REQUEST FOR TENDER RFT #B25-03

Washroom Upgrades
(Fenelon Twp PS, Bobcaygeon PS, IE Weldon SS, Lady Mackenzie PS)

TLDSB ADDENDUM NO. 6

RFTB25-03 Fenelon Township Public School Universal Washroom

1 Floor Plan Rm 118A NEW WORK
1:25

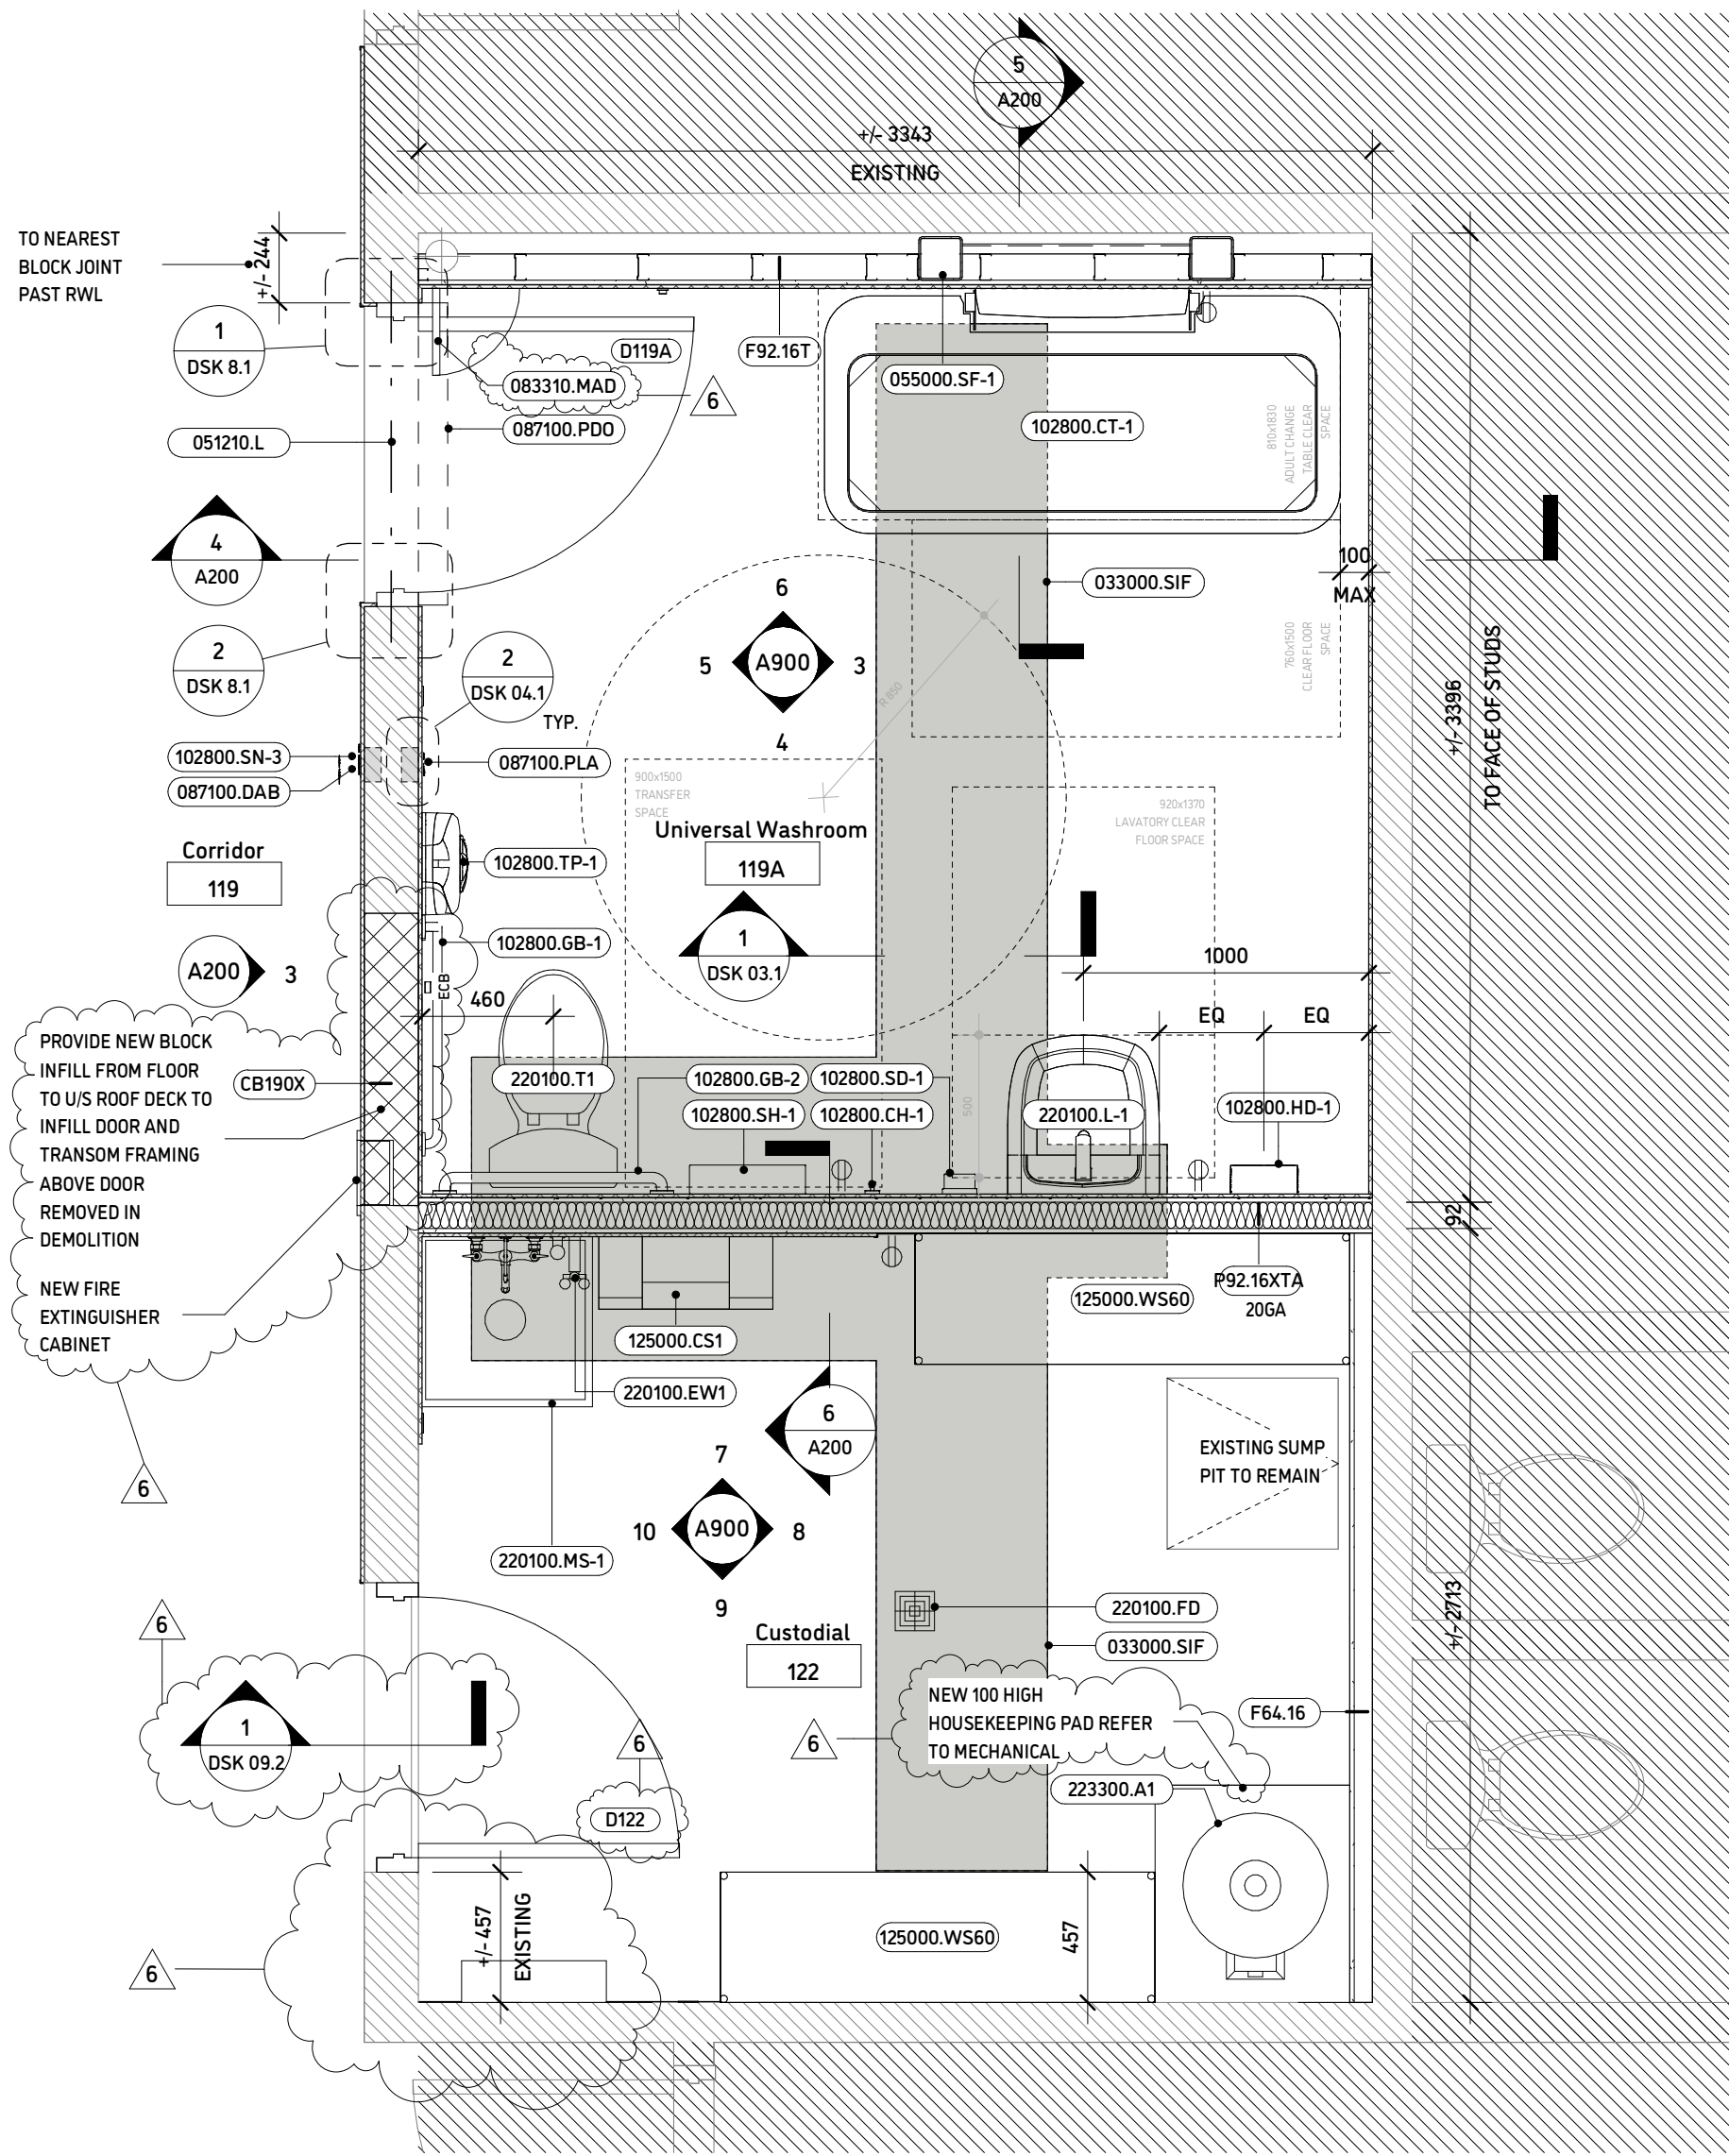
- 3.1 Refer to attached drawing A200 for the following clarifications:
 - 3.1.1. **CLARIFICATION: Drawing 1/A200 Location of existing custodial room D122 dimensioned. Refer also to electrical clarification below.**
 - 3.1.2. **ADD: Replacement fire extinguisher cabinet in Corridor 119. Product to be Herbert Williams Model #SR-108 or approved equal.**
 - 3.1.3. **CLARIFICATION: Concrete block infill at existing Rm 119A door opening.**
 - 1/A200 - Provide CB190X infill.**
 - 1/DSK 04.1 - refer to DSK 04.1 block partition details.**
 - No slab thickening is required as infill is over an existing foundation wall.**
 - 3/A200 - Provide tile control joints to nearest vertical tile joint each side of infill from floor to ceiling.**

- 3.1.4. **CLARIFICATION:** Drawing 6/A200 Tile height Custodial Rm 122. Tile height at mop sink to match adjacent door height to nearest tile module.
- 3.1.5. **CLARIFICATION:** Drawing 1/A200 - 100mm housekeeping pad noted below new HWT. Refer also to mechanical drawings.
- 3.1.6. **CLARIFICATION:** Drawing 1/A200 and 4/A200 – added keynote for new 12"x12" access door in north wall for existing rainwater cleanout.
- 3.1.7. **ADD:** Replacement of existing Custodial Room door D122. Refer to 1/A200, 3/A200 and Door Schedule on sheet A200.

SKM-01

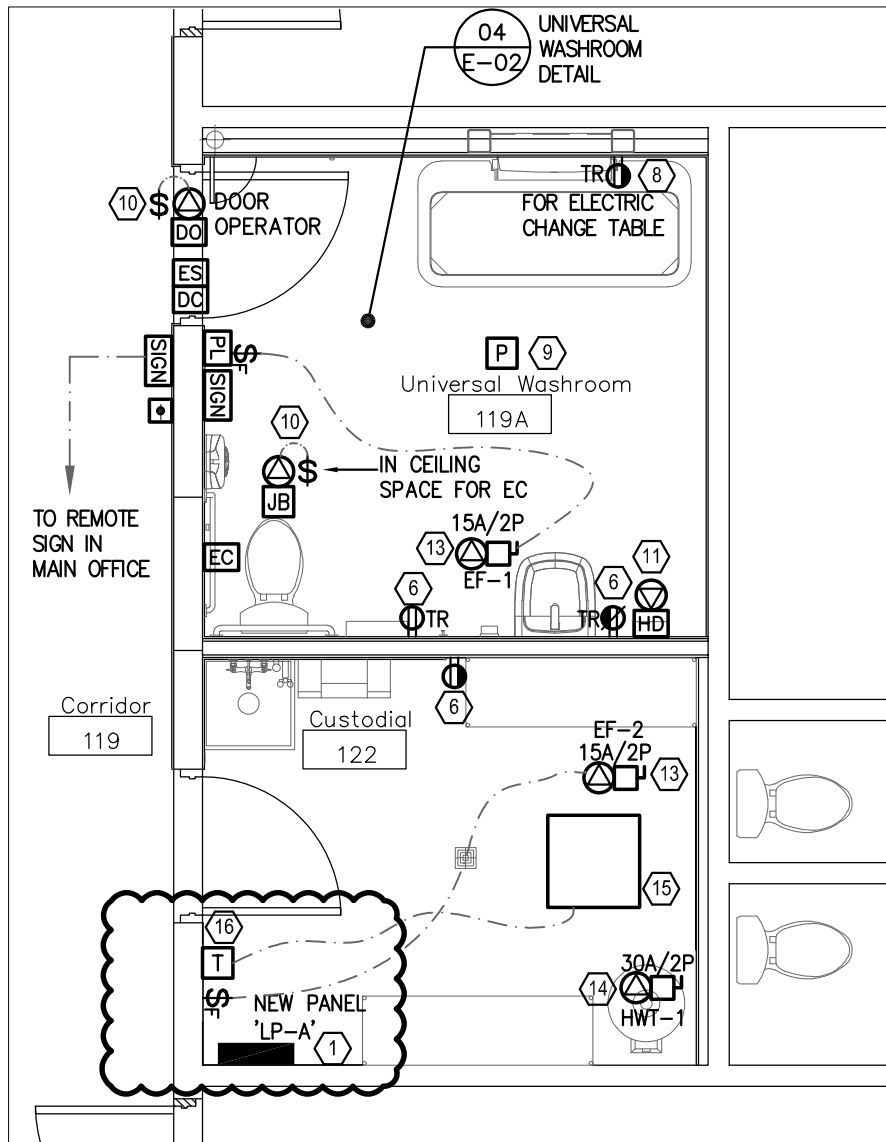
- 4.1 **Revised HVAC layout in Custodial Rm 122. Refer to attached ADD-M01 for clarification.**

- .1 Revise Proposed HVAC layout in Custodial Room #122, as shown on attached sketch SKM-01.
